### Remarks/Arguments

Claims 1-5 are pending in the application. By this Amendment, the specification is amended and Figures 5 and 6 are replaced.

TITLE: SPOOL-TYPE HYDRAULIC DIRECTIONAL  
CONTROL VALVE HAVING REDUCED CAVITATION  
INVENTOR: Mark John Cherney  
DOCKET #: 17008 /kjm, mah

5/6

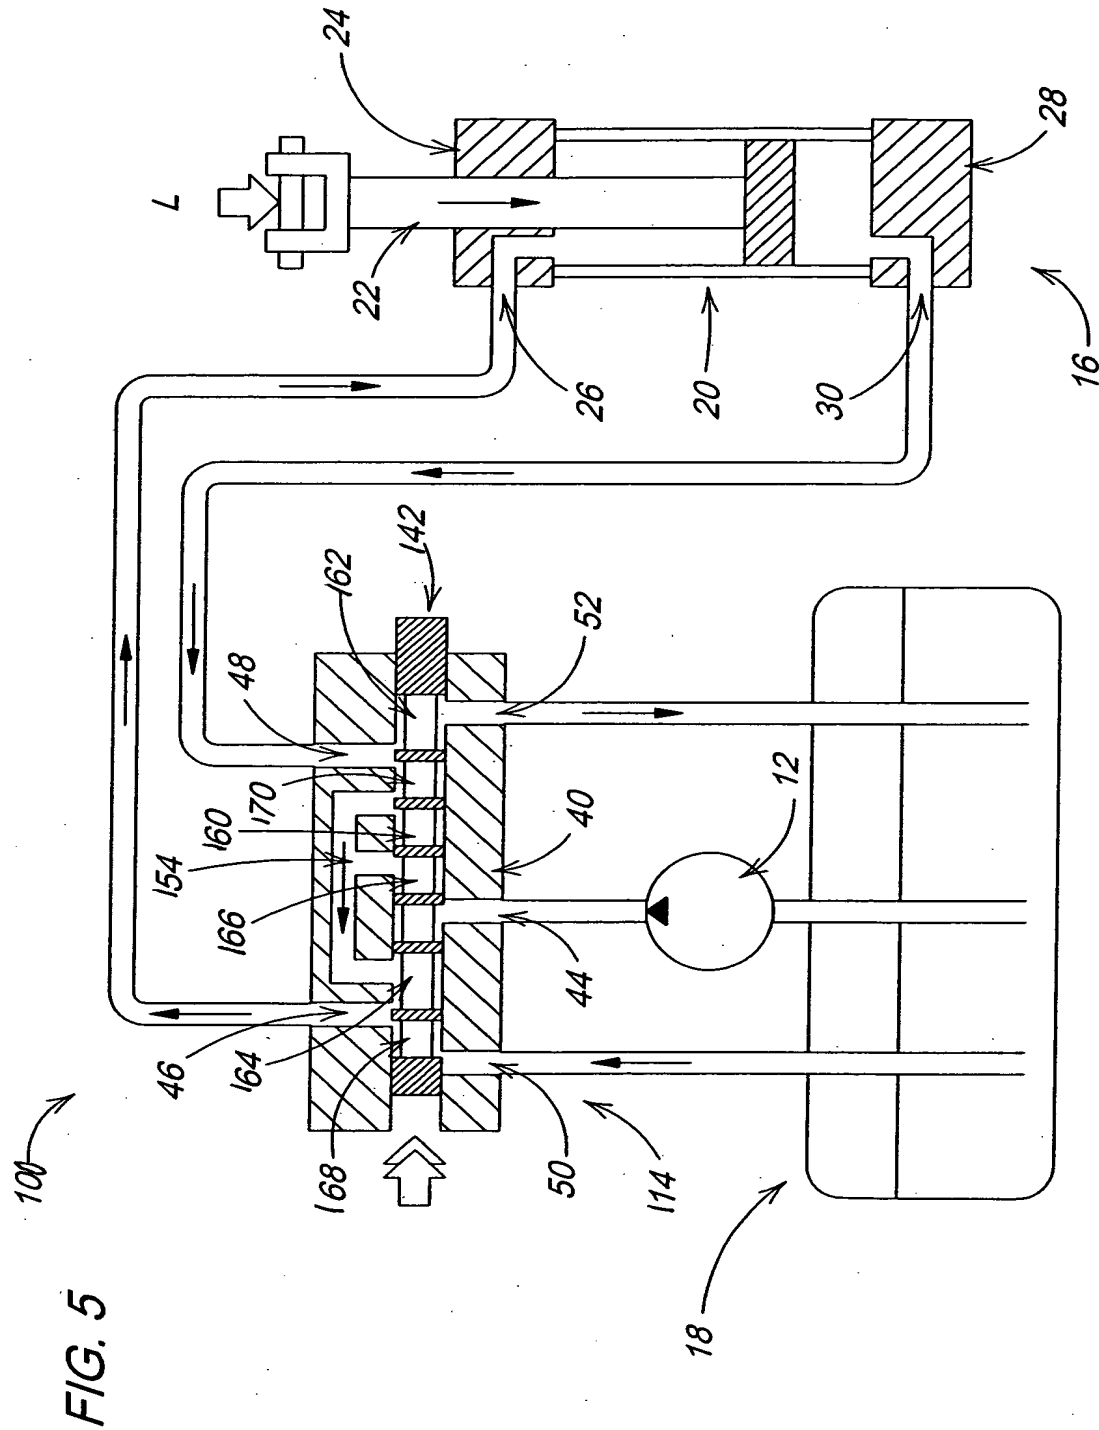
**[0025]** Figure 5 illustrates a first embodiment of the present invention. In this embodiment, the flow area of the first passageway 162 on the valve spool 142 is appropriately sized to reduce hydraulic fluid flow from the head end port 30 of the hydraulic cylinder 16 to the hydraulic fluid reservoir 18, such that a sufficient proportion of the hydraulic fluid expelled from the head end port 30 flows through the supply passage 154 of the control valve 14 and back to the rod end port 26 to reduce cavitation when the valve spool 142 is in the "float" position. For example, the first passageway 162 may be sized such that the ratio of flow through the second return port 52 compared with the flow through the second work port 48 is approximately the ratio of the square of the rod cylinder 22 diameter to the square of the cylinder body 20 diameter.

**[0026]** Figure 6 illustrates a second embodiment of the present invention. In this embodiment, the second passageway 268 on the

valve spool 242 is blocked-off, eliminating the flow path for hydraulic fluid to flow between the hydraulic fluid reservoir 18 and the rod end port 26 of the hydraulic cylinder 16 when the valve spool 242 is in the "float" position. Additionally, the flow area of first passageway 262 on the valve spool 242 is appropriately sized to reduce hydraulic fluid flow from the head end port 30 of the hydraulic cylinder 16 to the hydraulic fluid reservoir 18, such that a sufficient proportion of the hydraulic fluid expelled from the head end port 30 flows through the supply passage 254 of the control valve 14 and back to the rod end port 26 with minimal cavitation when the valve spool 242 is in the "float" position.

The attached sheets of drawings include changes to Figures 5 and 6.
